NABCO ENTRANCES TECHNICAL BULLETIN

GT1175 Stalling During Opening

Bulletin Number: **76**

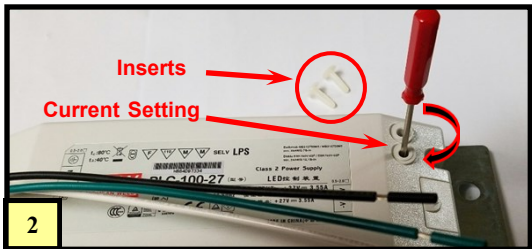
Issue: A few instances have been reported where a GT1175 auto slider will seem to stall out or hesitate while opening.

Reason: This has been traced back to an adjustment on the new white programmable power supply. Refer to Bulletin # 70. The voltage and current settings on the power supply may need to be altered slightly.

1. To adjust the voltage and current settings for power supply, first carefully remove both inserts in the upper right-hand corner of unit
